February 19, 2026

Re: Initial Peer Review of the Stormwater Design
305 North Main Street Andover, Massachusetts
MassDEP File No. 090-1459

Stormwater Review

Figure 1. Screenshot of plan sheet showing BVW boundary in blue with associated linear measurements for portions of it segmented via vertical red markers; approximate extent of buffer zone mitigation plantings shown in green; 50-foot buffer zone in orange

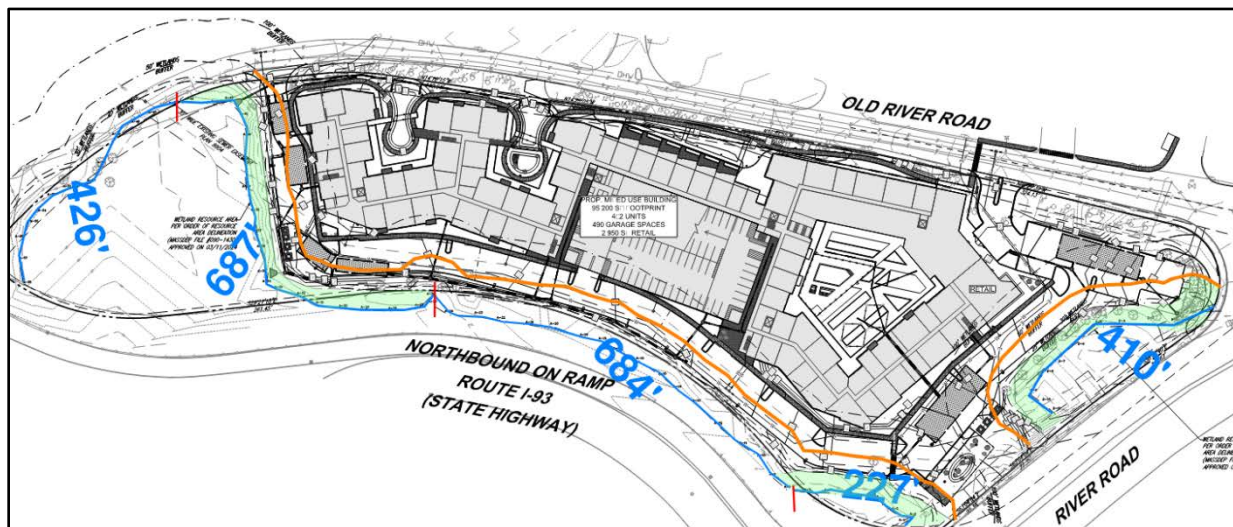
managed within the entire project site. However, HW notes that the buffer zone mitigation plantings are limited to three portions of the 0-25 foot Buffer Strip, encompassing less than half of the available 0-25 foot Buffer Strip area associated with BVW within the subject parcel (approximately 46%). Figure 1 within Section 2.0 provides a map of the areas where invasive species were identified, which encompasses the entire area surrounding the proposed re-development within the parcel. No plantings are proposed for the approximately 684-foot length section indicated in Figure 1 below.

Additionally, it appears that invasive species were not assessed for the entire extent of the 0-25-foot Buffer Strip that exists on the subject parcel, which exists between the roadways (i.e., Old River Road and the ramp to Route 93 Northbound) and the BVW in the northwestern portion of the parcel (see Figure 1 below).

14. HW recommends that the Applicant clarify the language in the narrative to accurately represent the extent to which mitigation is proposed¹.

As shown in Figures 1 and 2, the proposed mitigation does not extend for the entire setback zone as designated by the local bylaw and implementing regulations, which specify that parking lots for four or more vehicles be set back 50-feet from resource areas and that access roads (except those allowed as a limited project) be set back a minimum of 35-feet from resource areas. Additionally, buildings/structures that require a building permit must be set back a minimum of 50-feet from resource areas. HW notes that the Applicant has included buffer zone lines for the 0-25 foot, 0-30 foot, 0-50 foot, and 0-100 foot buffer zones on the project plans.

17. HW recommends that the Applicant clarify the proposed development and the Planting Plans' conformance with the local setback requirements.
